COTTAGE GARDENS

AN ADDITION TO WICHITA - SEDGWICK COUNTY, KANSAS

Re: S/D 90-64 (Final Plat) Cottage Gardens Addition

CASE NUMBER: S/D 90-64 - COTTAGE GARDENS ADDITION

FINAL PLAT

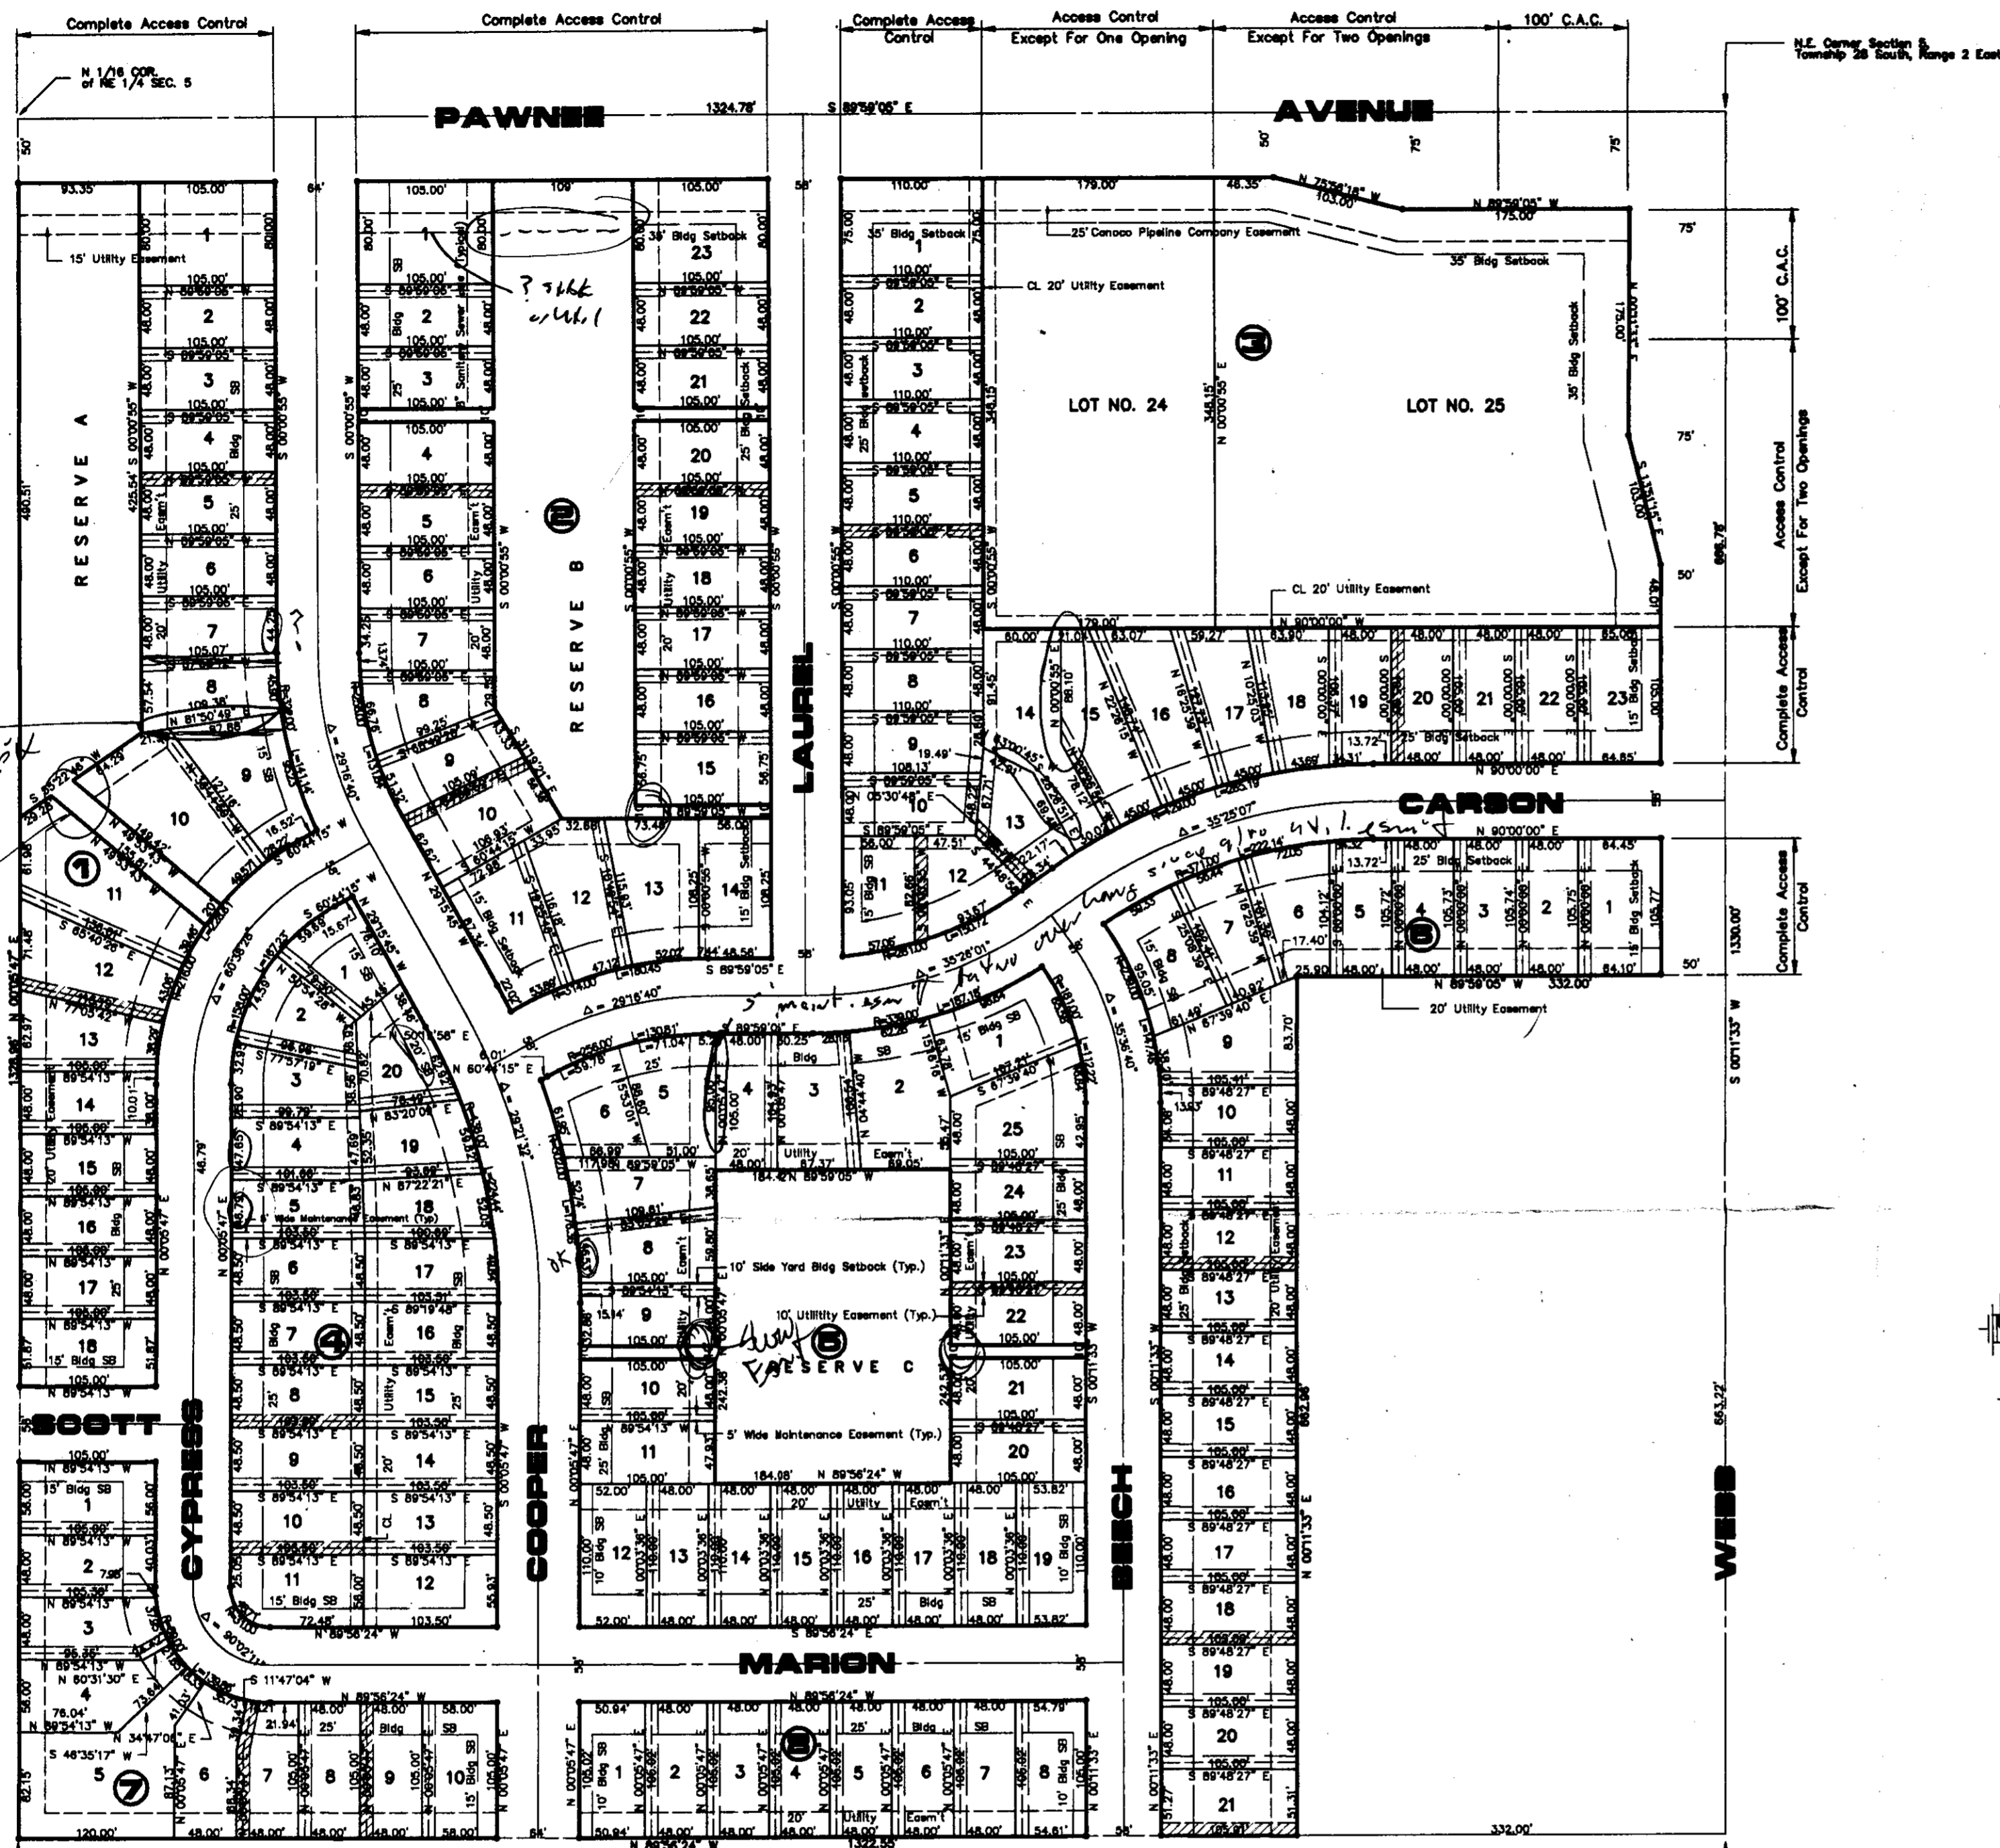
- Z. The utility easement and/or setback along the north line of the residential lots and Reserve B adjacent to Pawnee shall be clearly labeled with the dimension of the setback (35-feet), or of an easement. It shall be clearly indicated as such. In particular if an easement is to cross Reserve B, and shall be shown along the north end of this Reserve and Lots 1 and 23 either side of the Reserve.

M. The final plat shall indicate the recording information for the Conoco pipeline easement on this property.

N. On the final plat, the center lines (CL) of Webb and Pawnee shall be labeled.

O. Because of the use of 10-foot sideyard setbacks required for zero lot line development, certain corner lots will be very limited in the buildable area available when a typical 15-foot sideyard setback is also required. It is recommended therefore that a 10-foot sideyard be allowed for a corner lot in cases where the building area would be less than the typical 38 foot areas of the majority of the lots. For example, Lot 8, Block 8 and Lot 19, Block 2 would only have a 30-foot width for building.

P. The present print on the final plat, particularly the dimensions, bearings, size of easements and setbacks, etc. on the face of the plat, are too small for microfilming and are of a size not accepted by the Register of deeds for recording a document. The

- Q. Except when located on a corner, lot frontages at street right-of-way should meet the minimum standard. For this cluster development a 48-foot frontage should be maintained unless physical constraints can be identified. In particular, Lot 7, Block 1 and Lots 4 and 5, Block 4 should be able to conform to the 48-foot minimum frontage by the shifting of lot lines of adjacent lots.

- R. On Lot 15, Block 3, the maintenance easement and zero foot sideyard setback should be continued along this lot's west line in order to allow Lot 14 to use the zero lot line option in the buildable area of this lot. If lot 13 of this Block is also intended to be used for a zero lot line home, a maintenance easement and sideyard setback should be shown along the southwest line of Lot 14.

- S. For Lot 4, Block 5 a zero lot line could be allowed if a 5-foot maintenance easement is shown along Lot 5, within the utility easement. However, no roof overhang should be allowed where an overlapping utility easement is also present. Consequently, the plat's text would need to be amended to indicate that the roof overhang would not be allowed if the 5-foot maintenance easement was also located in a utility easement.

- T. On the final plat tracing, where utilities are crossing the Reserves, such as along the north line of Reserve B, the south line of Reserve A, and the two entrances to Reserve C, utility easements shall also be clearly indicated as crossing these Reserves.

- U. Easements were requested by the Utilities between: Lots 2 and 3, Block 4, Lots 19 and 20, Block 4 and Lots 4 and 5, Block 6. These easements shall be indicated on the final plat tracing.

- V. On the final plat tracing an insert of an enlarged area of lots shall be provided to better indicate the platting of the 5-foot maintenance easement, 10-foot sideyard setback and in certain cases the overlapping utility easements.

- W. On the final plat tracing the word "Acting" shall be deleted from the MAPC signature block.
- X. The applicant is advised that the buildability of Lot 10, Block 3 is questionable. A 10-foot easement and a 10-foot sideyard setback will leave a buildable width of 28-feet for this lot.

- Y. Unless a maintenance easement and sideyard setback are platted on Lot 5, Block 7, this Lot could only be developed for a conventional or non-zero lot line home
